D.N.D.

SMALL HOUSE DESIGNS

PREPARED BY CENTRAL MORTGAGE & HOUSING CORPORATION

Preliminary Resume of D.N.D. House Designs

L/54/T

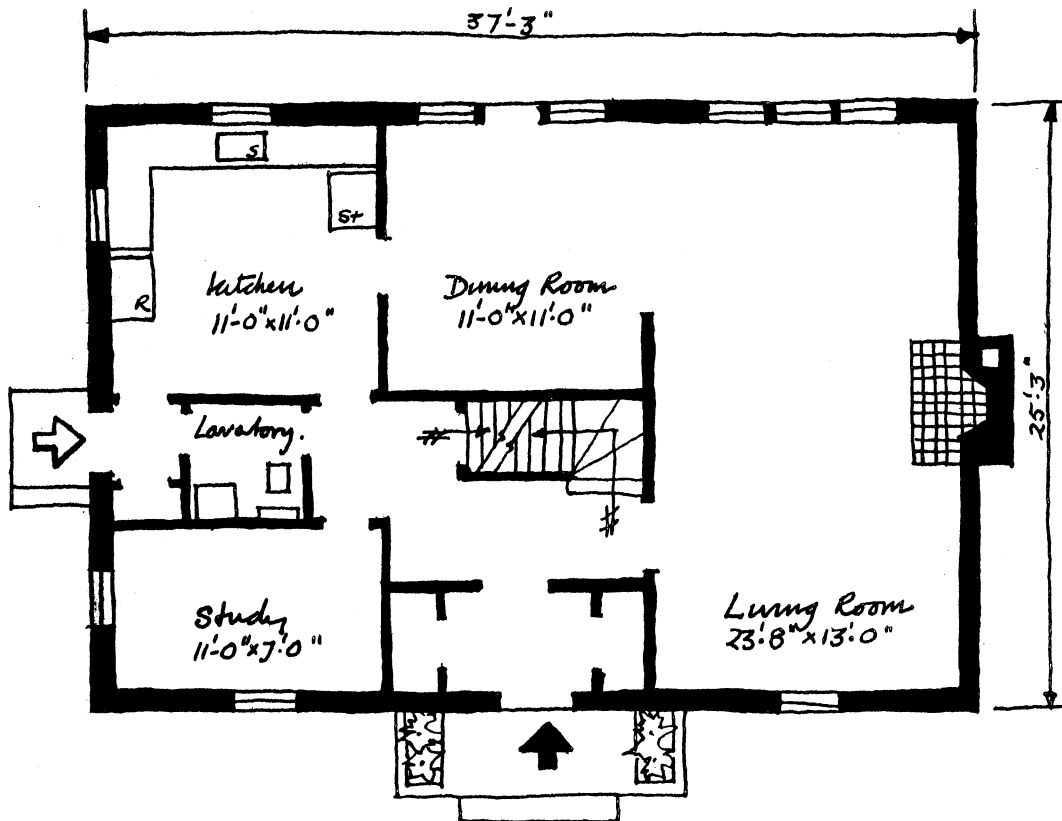
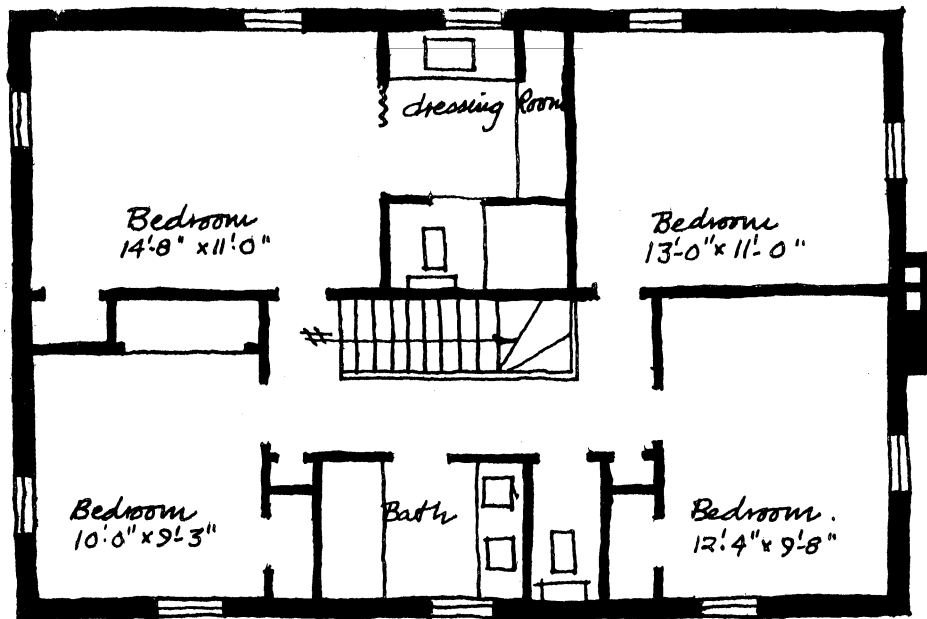
(Acceptable to AIR FORCE with reservations)

(Acceptable to ARMY for Gagetown)
